Model: Aprilia RSV4 - Tuono V4 1100 E5

Subject: Availability of engine ECU calibration update

Figure 1

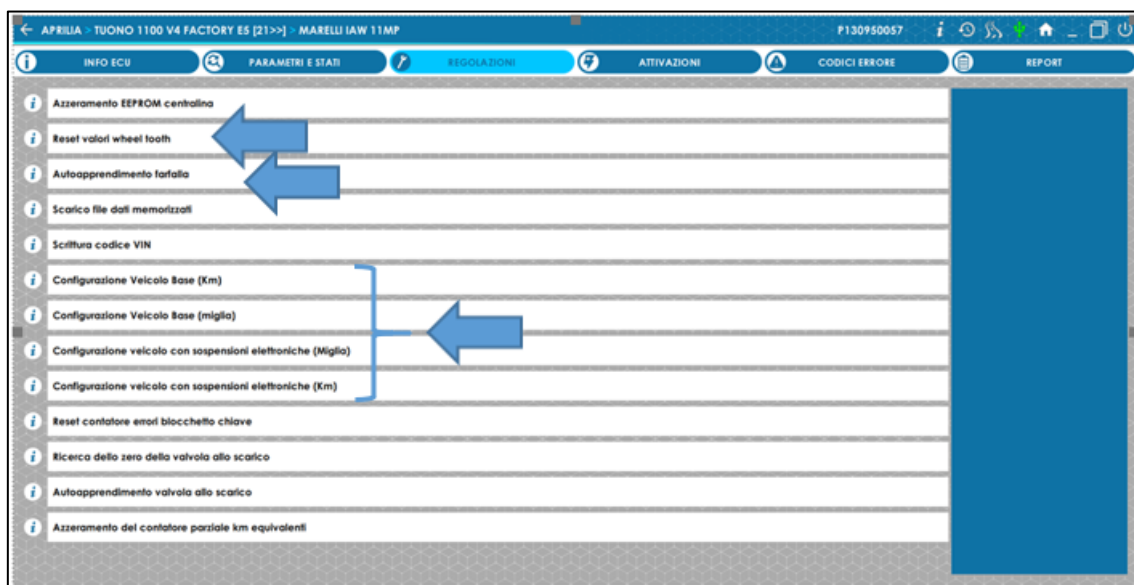
- Perform a key off / key on
- Carry out the throttle self-learning procedure (see figure 1 or 2)
- Perform the vehicle configuration procedure (see figure 1 or 2)
- Perform a key off / key on
- Perform the tone wheel learning procedure (see procedure below for EMEA versions only*)
- Access the vehicle ECU menu and cancel any errors.

- Perform the cycle “Reset wheel tooth values” with the PADS diagnostic tool (see figure 1 or 2);
- Warm the engine to 80°C;
- With the gearbox in neutral, the side stand extended and the vehicle completely stationary, throttle up to over 8000 rpm three times for over 1 second;
- Switch the ignition off and wait at least one minute (Power Latch);
